PREVOST

**SAFETY
RECALL**

SR22-311

| SUBJECT: | PASSENGER SEATS INSPECTION - RECLINE MECHANISM C-CLIPS & PINS FALLING OFF | |

Figure 1: SEEN FROM THE SIDE (FIXED SEAT SHOWN, SIMILAR ON SLIDING SEAT)

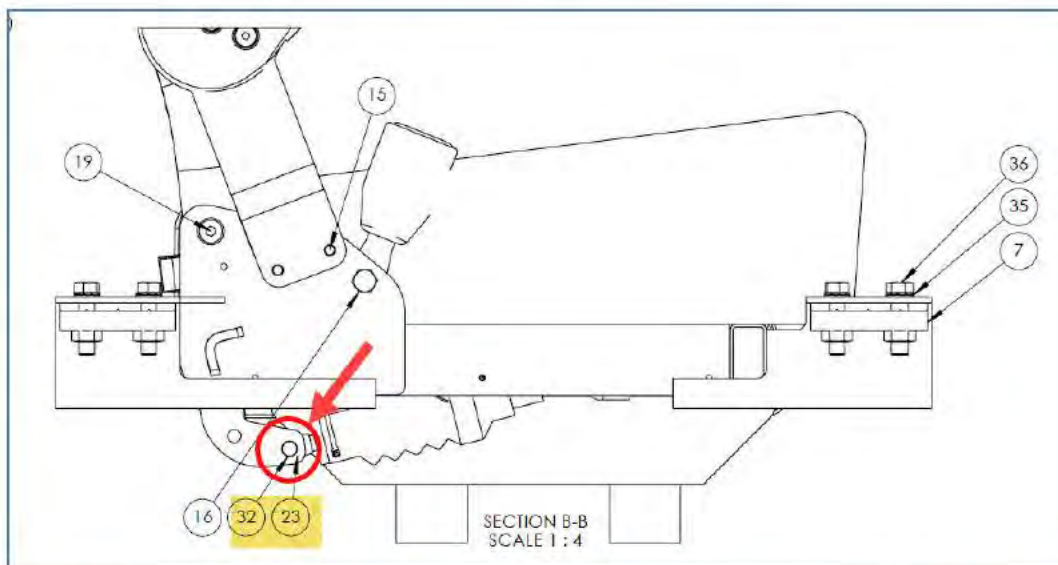
C-clip that holds the pin in place at the connection point with the backrest falls off and missing. Once the pin holding the recline mechanism comes out the seat, the reclining function doesn't operate properly.

1. **FIXED SEATS & SLIDING SEATS.** At the connection point with the backrest, make sure that the pins (2 per seat) and c-clips (2 per seat) are present and installed properly. See Figure 1 and Figure 2 to locate the potentially missing C-clips and pins.
2. Correct any faulty installation. Install a C-clip and a pin where missing.
3. Record any faulty installation and the quantity of missing pins & C-clips for this coach.
